PLANNING COMMISSION MEETING

Project Name: Culver's
 Description: Final site plan approval and PDA approval recommendation
 Date on Agenda this packet pertains to: October 3, 2024

RE: Culver's- Final Site Plan/Final Engineering Plan Review – 2nd Review

**Revised Final Site Plan Review
for
White Lake Charter Township, Michigan**

CULVER'S
 NORTH EAST 1/4 SEC 20
 TOWNSHIP 3N, RANGE 3E
 BOGIE LAKE ROAD
 WHITE LAKE TWP., MI
 SITE LANDSCAPE PLAN

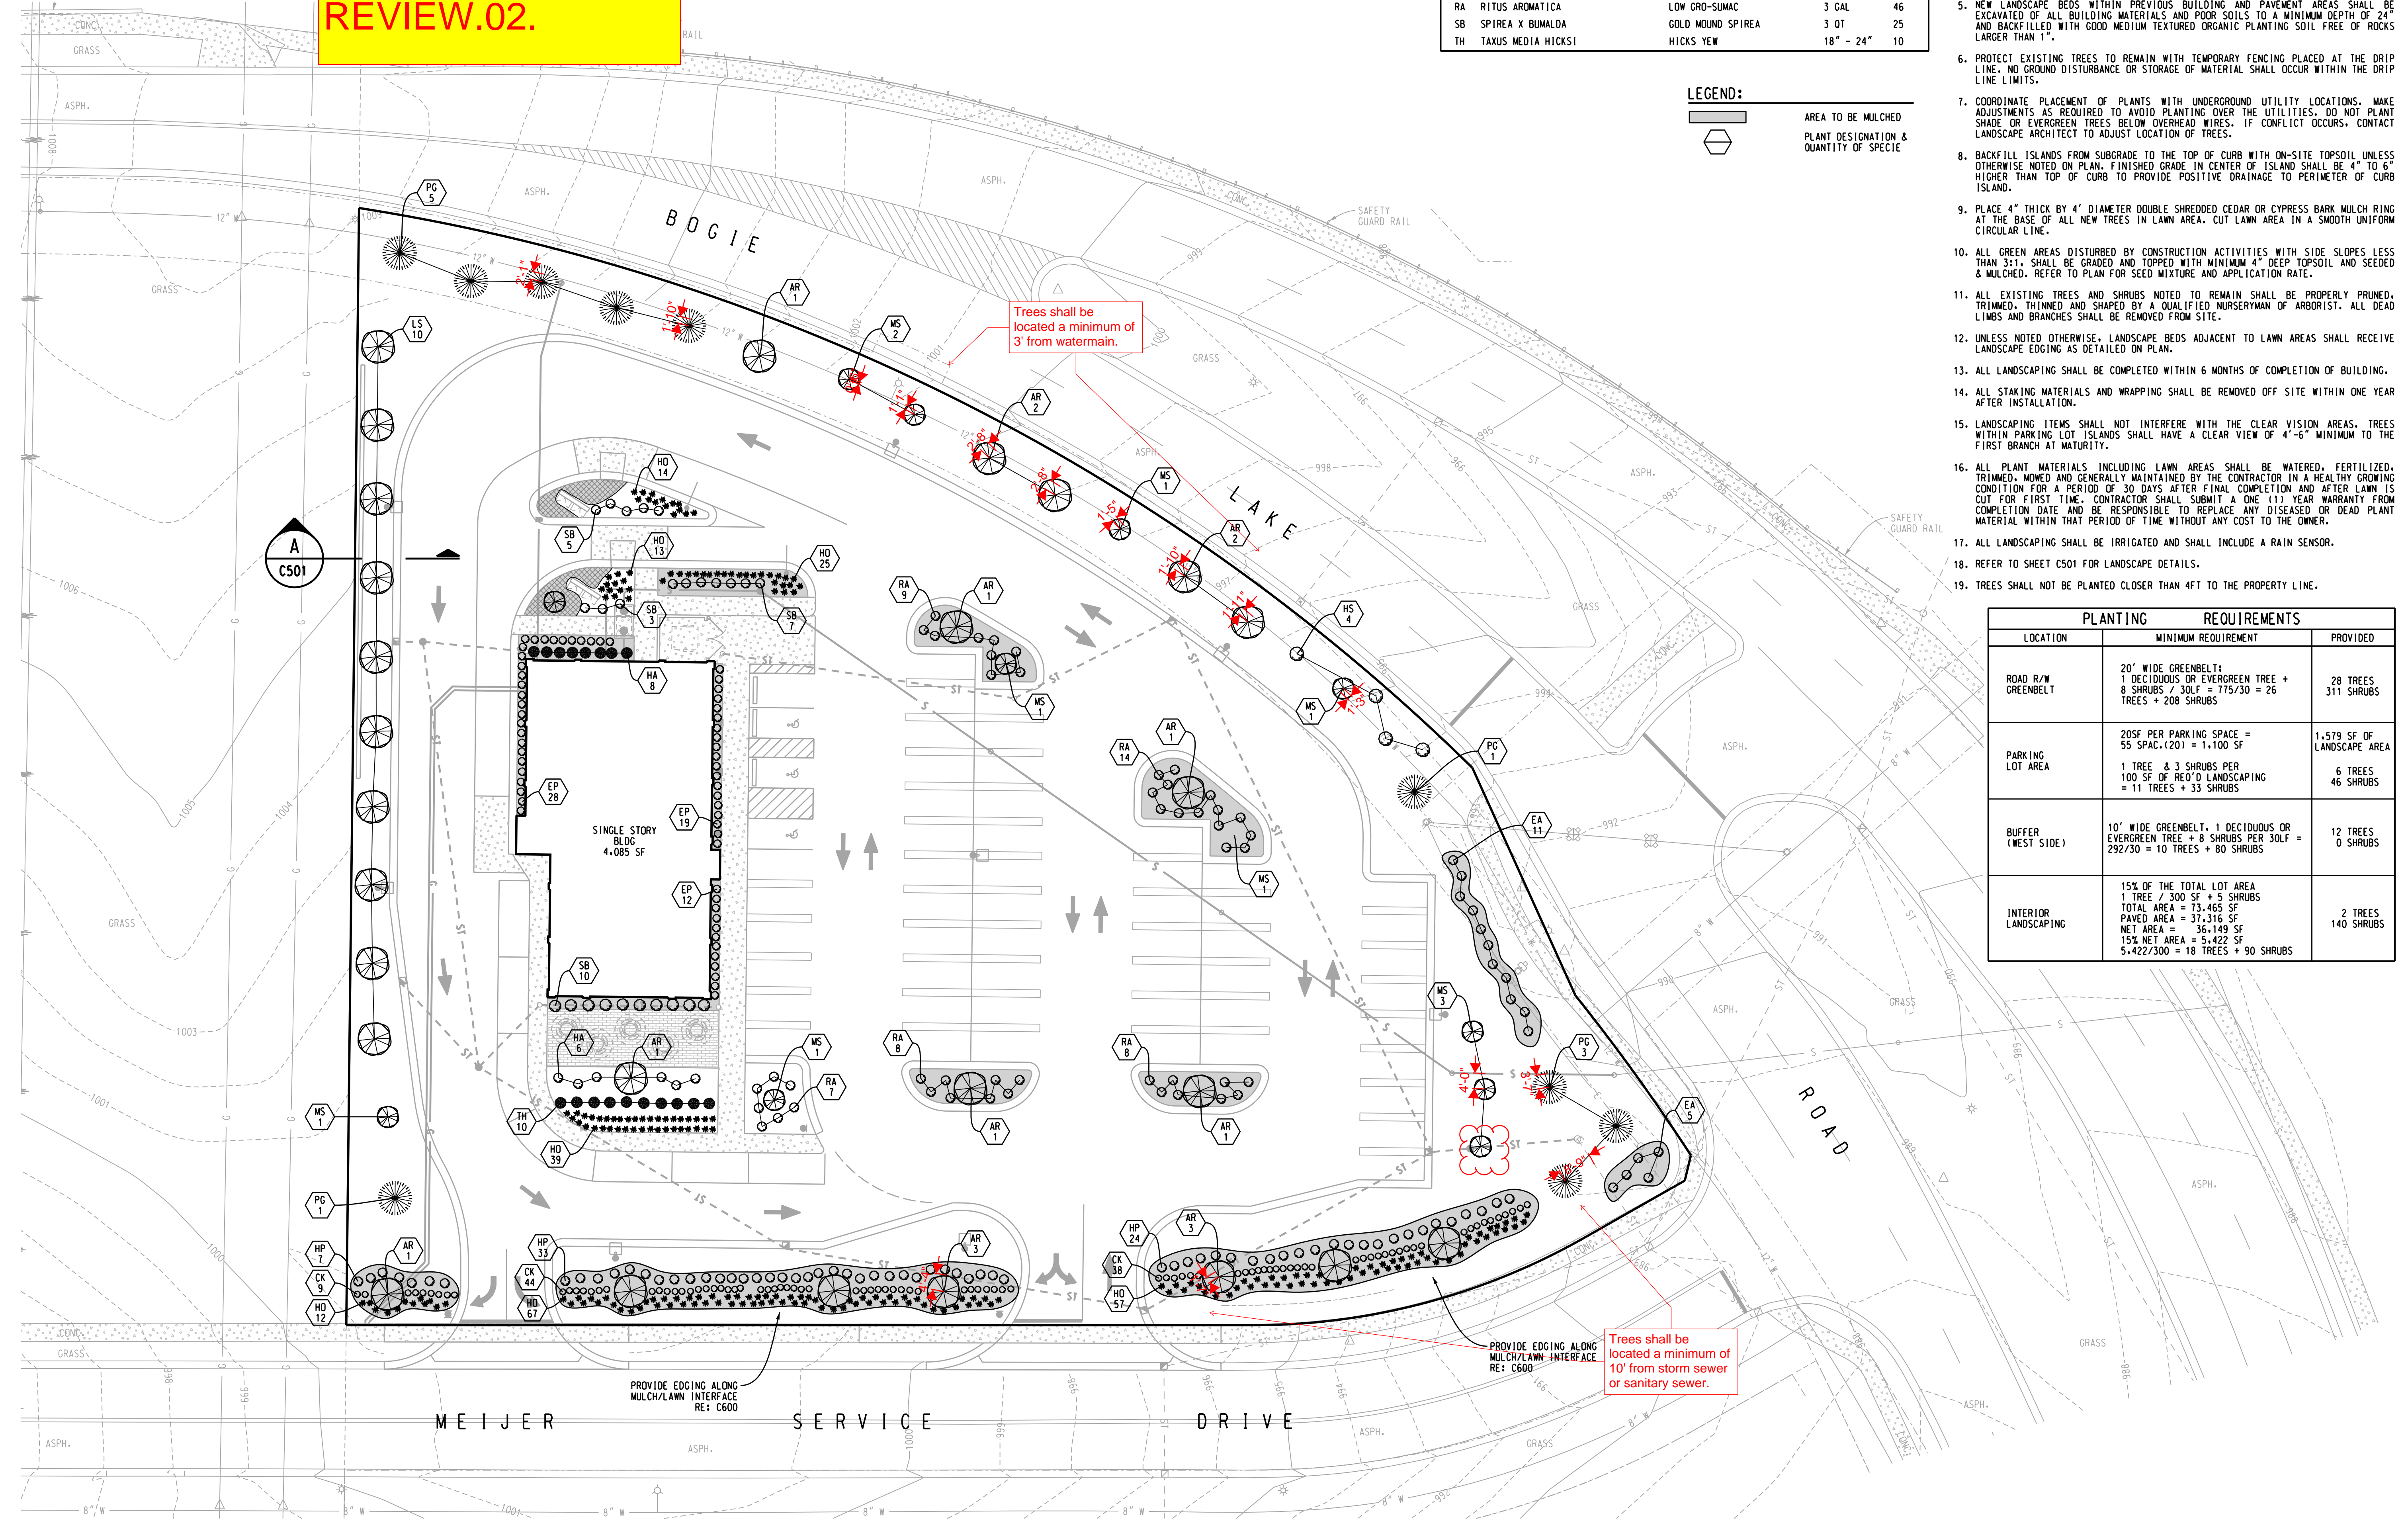
2. *Sheet C500- Shift Redspire Pear tree, located SE of CB7, to the east to provide 10' horizontal separation between storm sewer and tree. **Comment rescinded. Landscape plan has been redesigned.***
3. Sheet C500-There are several areas on the redesigned plan where proposed trees are too close to water main and storm sewer. Please reference enclosed red lined landscape plan sheet.

PHASE: F. SPA
JOB NO.: 230601
C301

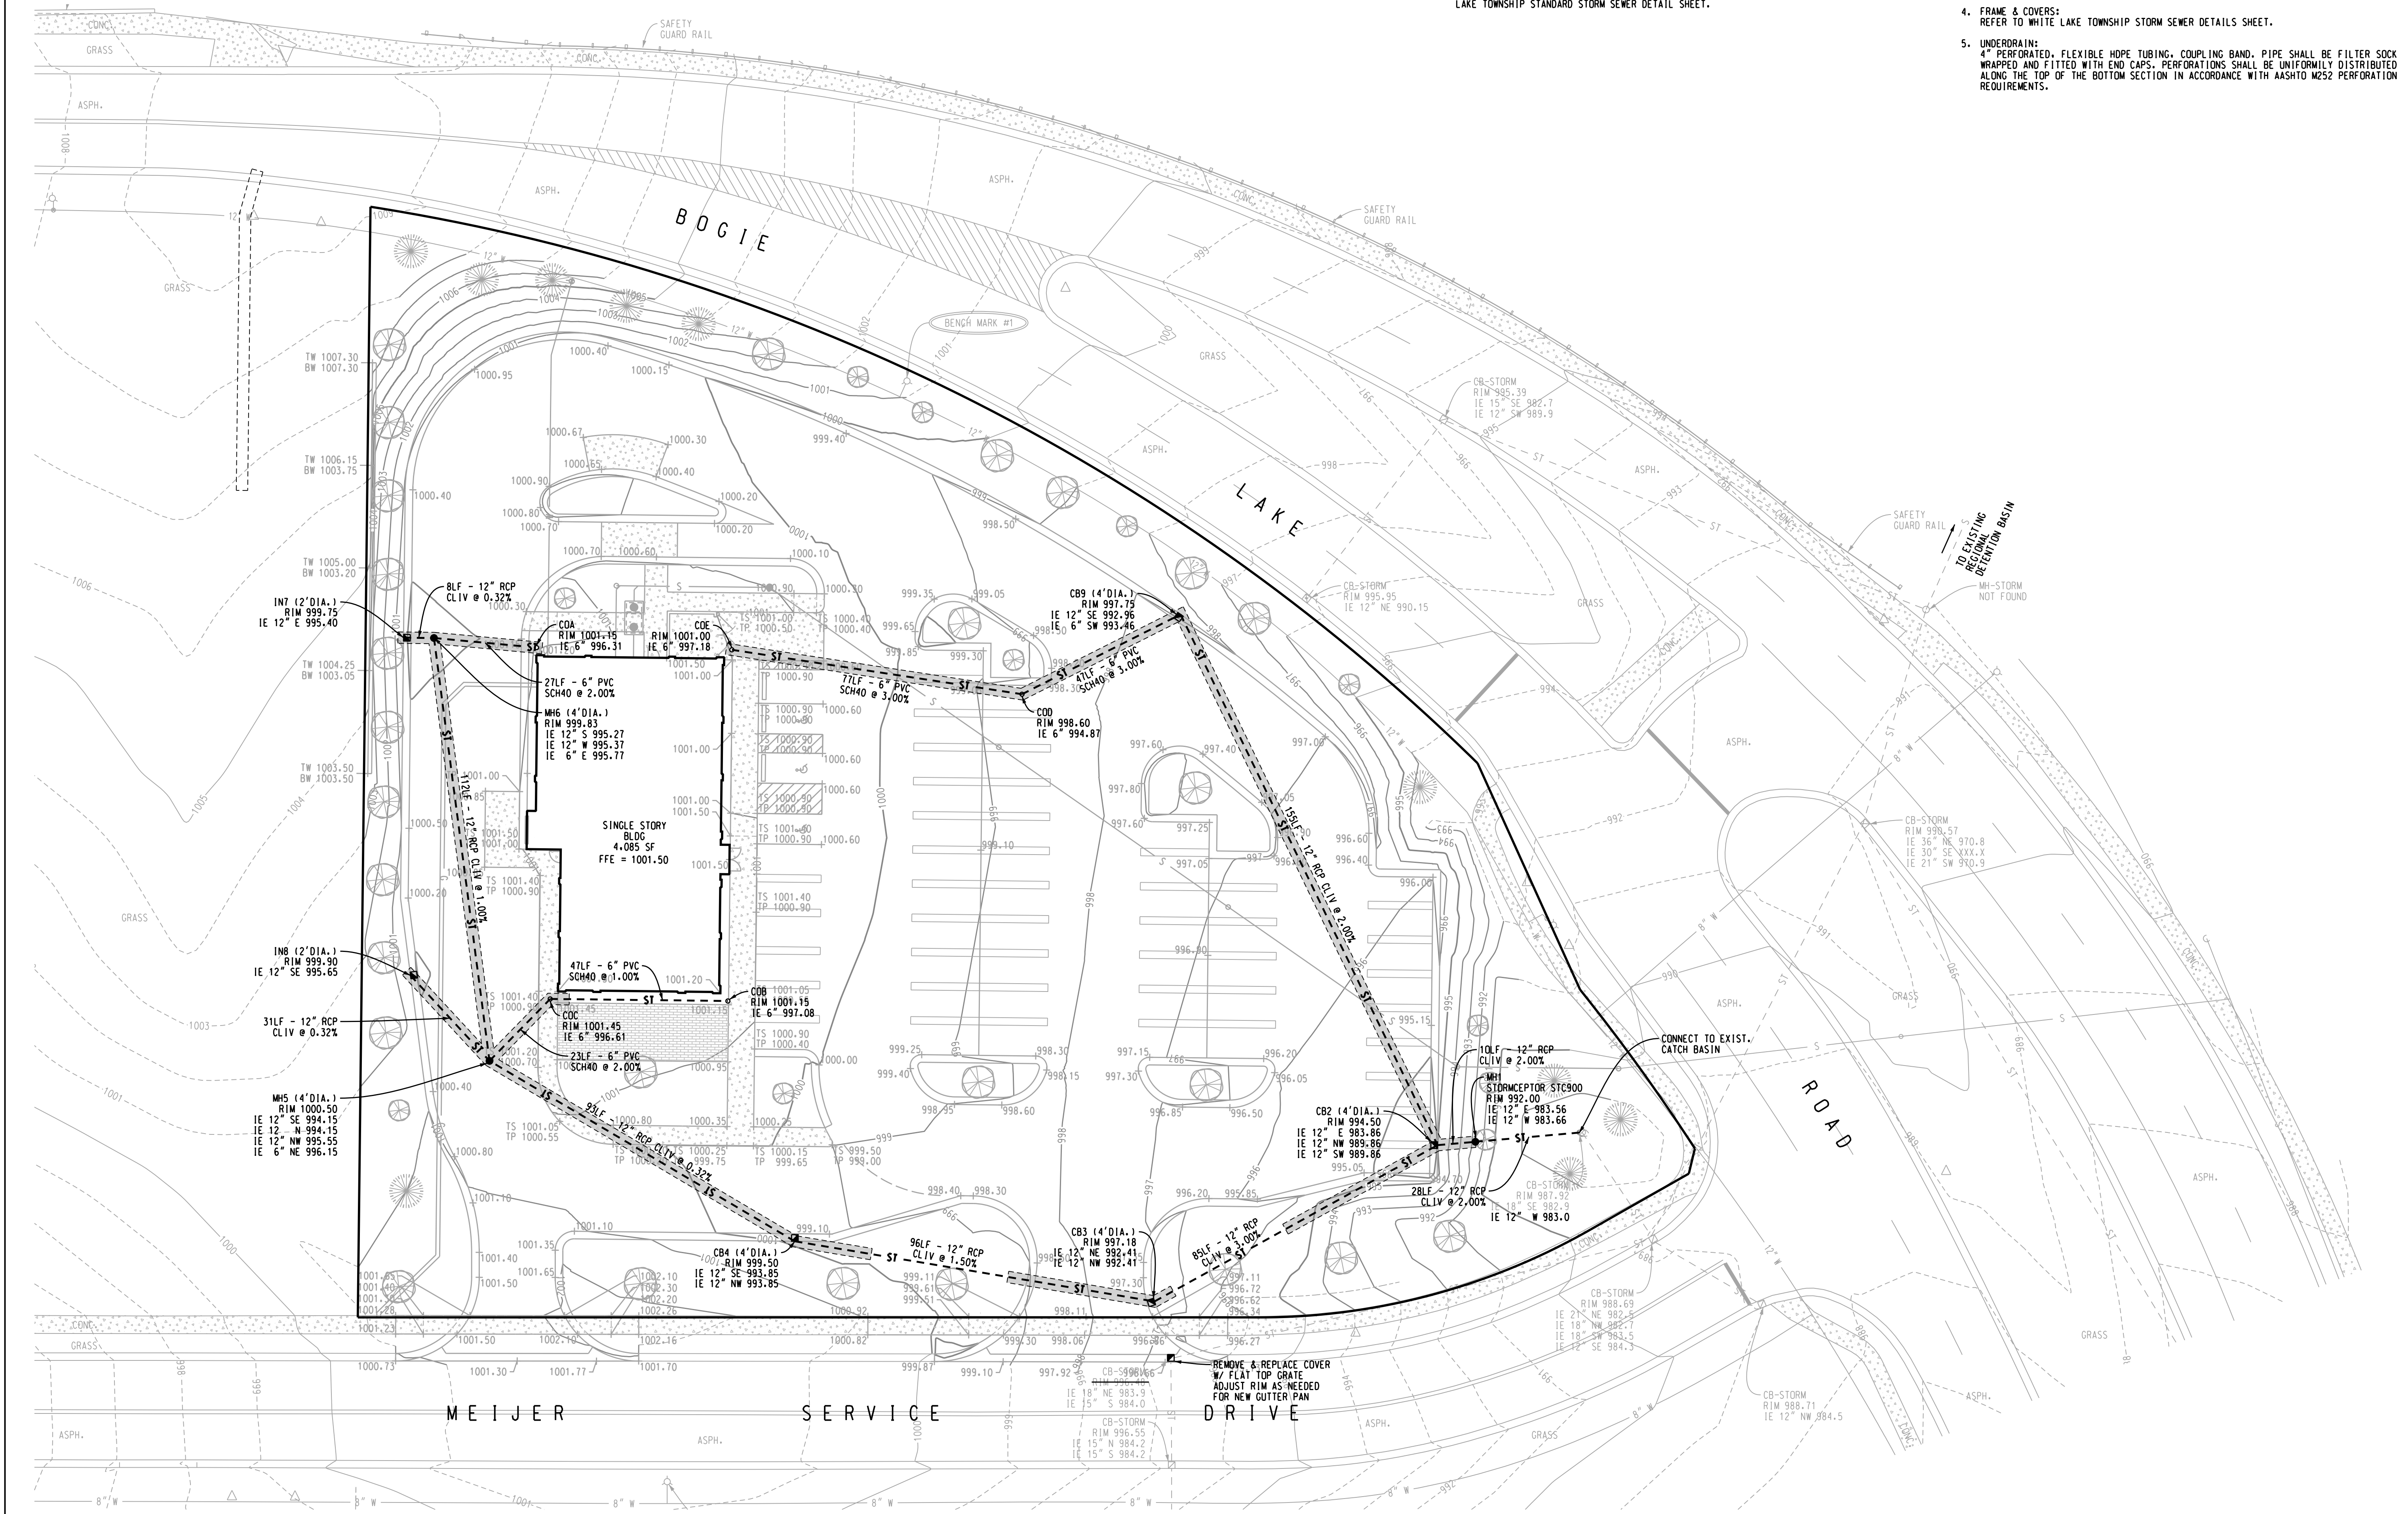
2. *Sheet C301- Inlet 8 is specified as a 4' diameter structure. A 2' diameter structure is allowed for this inlet. **Comment addressed. Inlet has been revised to a 2' diameter structure.***

5. *Sheet C301- Show electric, gas, water, and sanitary in light shade/background in order to show areas where utilities cross. **Comment addressed. Above mentioned utilities are now shown on this plan sheet.***

7. *Sheet C301- Indicate what the dashed line segment to the west of the Culver's site is.*
8. *The following labels for storm sewer structures shall be revised: 1) Sheet C300-Storm rim labeled as 'COE' near parking lot island should be 'COD.'; 2) Sheets C302 and C303-a) 'COD' by building is 'COE.' ;b) Label 'COD' by parking island; c) 'CB7' is 'CB9' (correctly shown as CB9 on site grading plan, site storm sewer plan, and storm sewer profiles).*
